ACTION: Supplemental notice of proposed rulemaking (NPRM); Reopening of the comment period.

[Docket No. 92-CE-63-AD]

Airworthiness Directives; Piper Aircraft Corporation PA-25 Series Airplanes

Piper Aircraft Corporation: Docket No. 92-CE-63-AD. Supersedes AD 93-21-12, Amendment 39-8763.

FIGURE 1

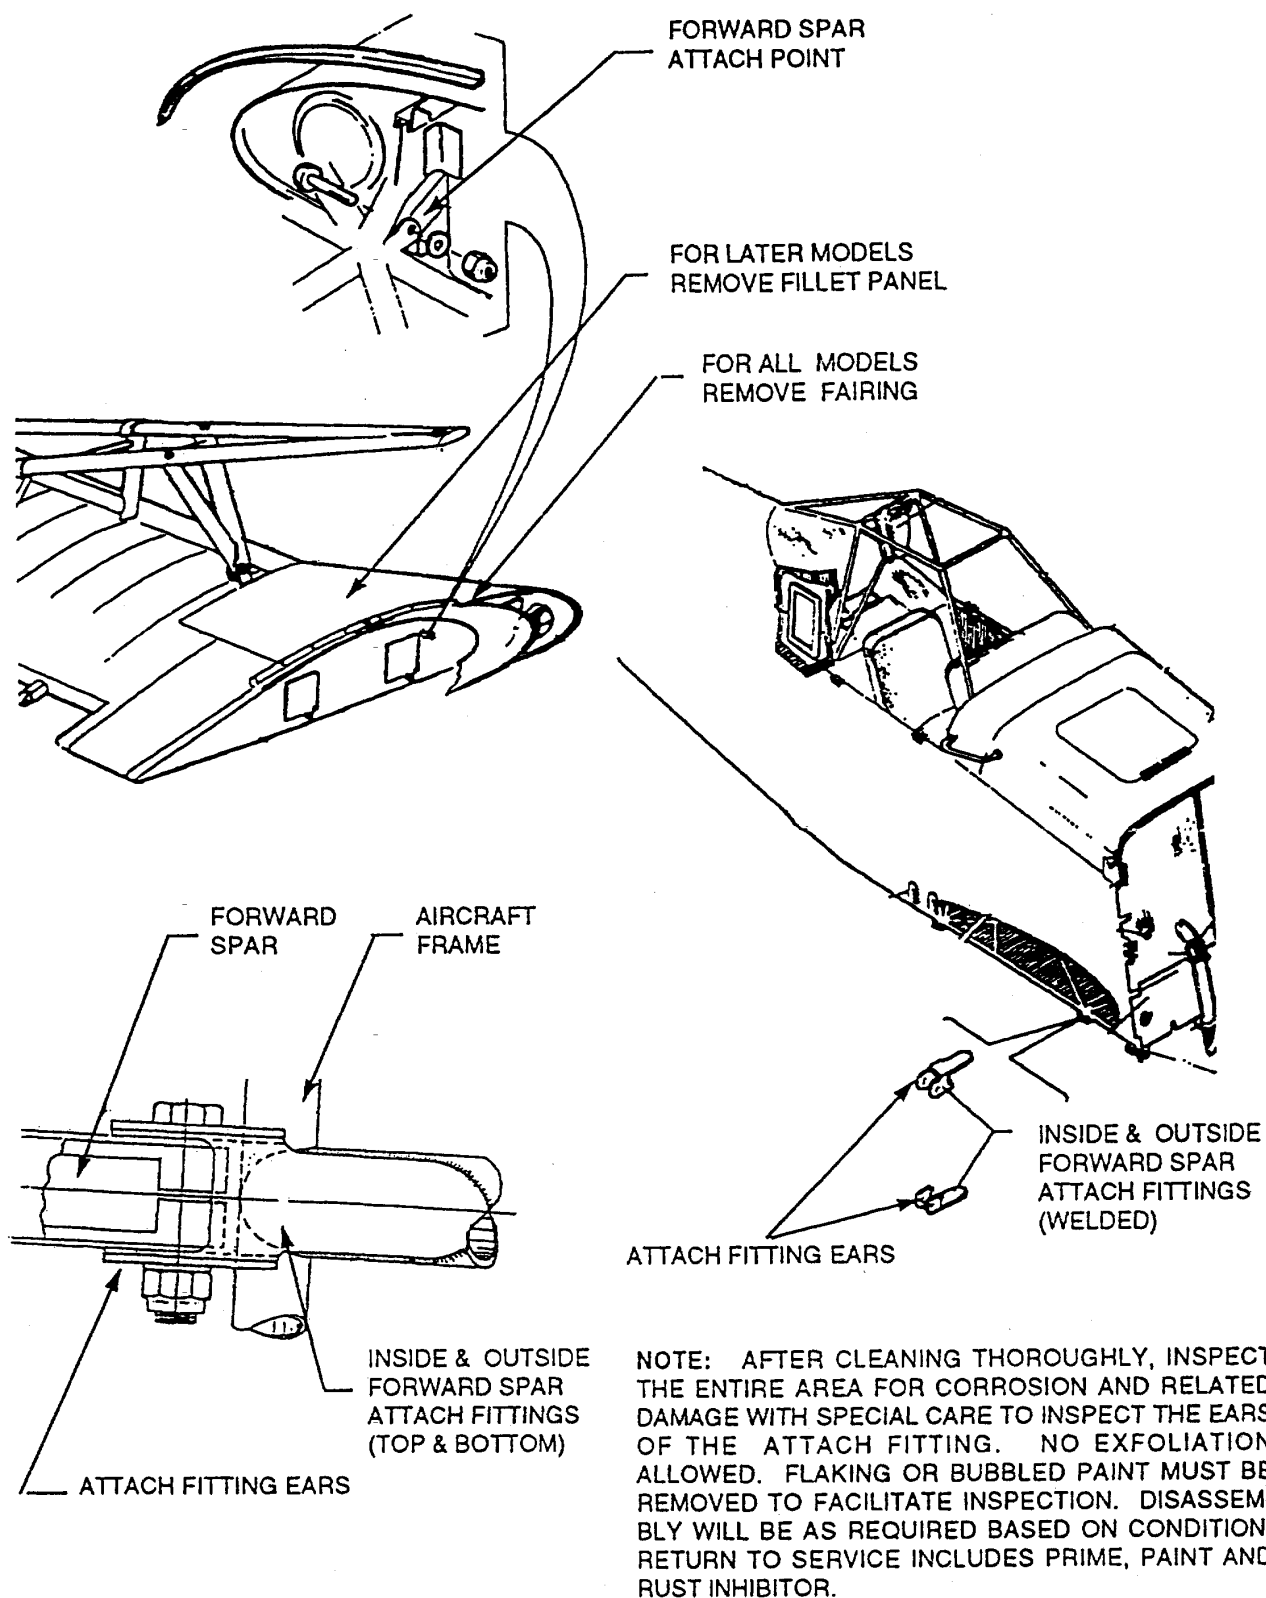
(a) Gain access to the left and right wing forward spar fuselage attach fittings by removing the screws retaining the wing fairing. Dismantle the wing fillet by removing the screws on the aft edge top and bottom and removing the wing fairing (see Figure 1 of the Appendix to this AD).

Figure 2

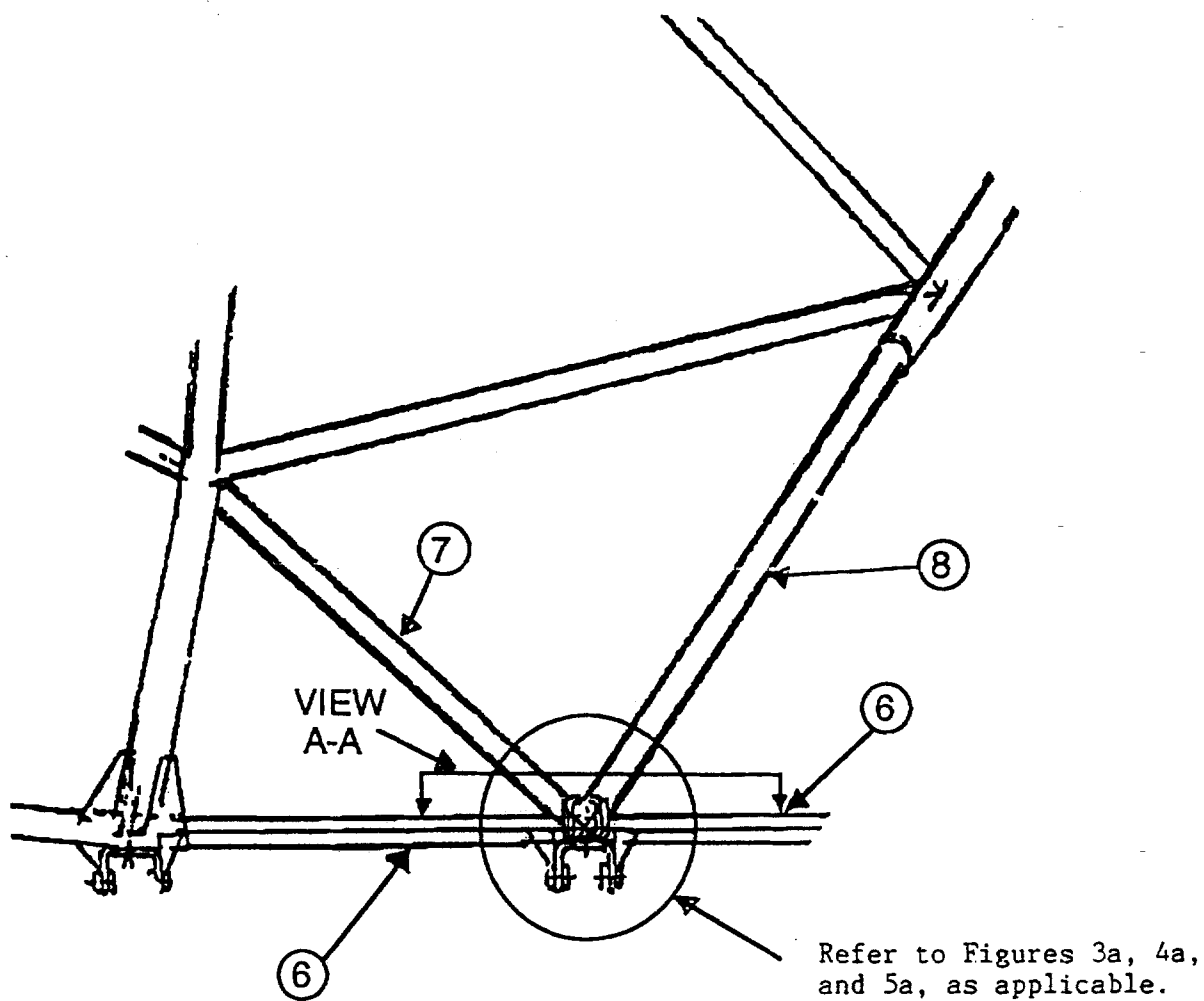
b. Cut the tubular members as referenced and specified in Figure 2 and either Figures 3a and 3b; Figures 4a and 4b; or Figures 5a and 5b, as applicable.

2. Cut the tubular members as referenced and specified in Figure 2 and either Figures 3a and 3b; Figures 4a and 4b; or Figures 5a and 5b, as applicable.

Figure 3a

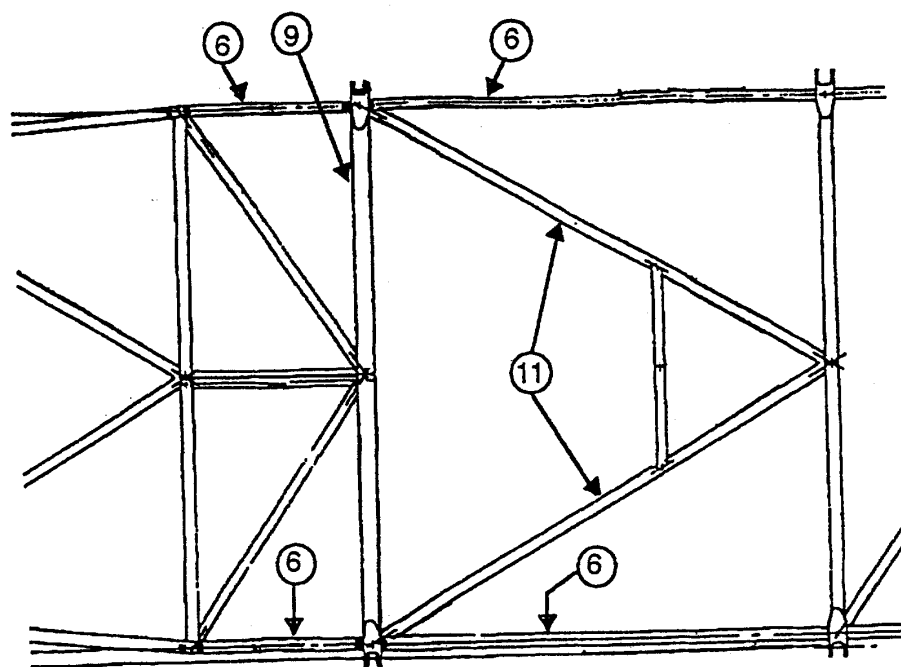
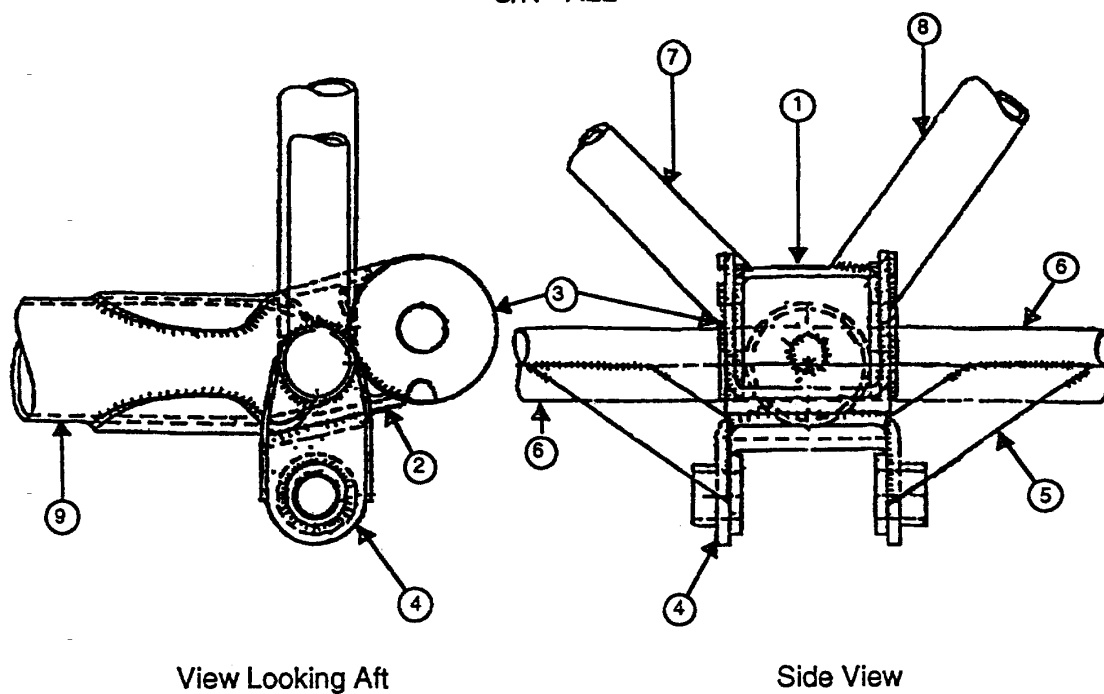
(e) Replacement parts required by this AD shall be of those referenced and specified in either Figures 3a and 3b, 4a and 4b, or 5a and 5b (as applicable), included as part of the Appendix of this AD.

1. Add couplant to the outside inspection surface (Refer to Figures 3a,

4a and 5a, as applicable). Add the appropriate gain to obtain the backwall echo from the inspection surface. If the gain setting is adjusted, re-check the thickness values on the steel shims. To assure proper coupling to the test sample, twist the probe clockwise and counter-clockwise (with a 45-degree twist) and maintain contact with the test surface. During the articulation of the probe, observe the A-trace on the screen and stop the probe twist at the point of adequate back surface signal amplitude to trigger the thickness gate on the first half-cycle. Measure and record the thickness. Repeat the above process at eight equally-spaced locations around the surface. The weld bead near the spar cluster may be hard to access. Find a suitable location near the weld and measure the thickness.

2. Add couplant to the inside inspection surface (Refer to Figures 3a, 4a and 5a, as applicable). Add the appropriate gain to obtain the backwall echo from the inspection surface. To assure proper coupling to the test sample, twist the probe (clockwise and counter-clockwise with a 45-degree twist). During the articulation of the probe, observe the A-trace on the screen and stop the probe twist at the point of adequate back surface signal amplitude to trigger the thickness gate on the first half-cycle. Measure and record the thickness. Repeat the above process at eight equally-spaced locations around the surface.

c. Fabricate a cluster using all applicable part numbers referenced in Figures 3b, 4b, or 5b, as applicable; and
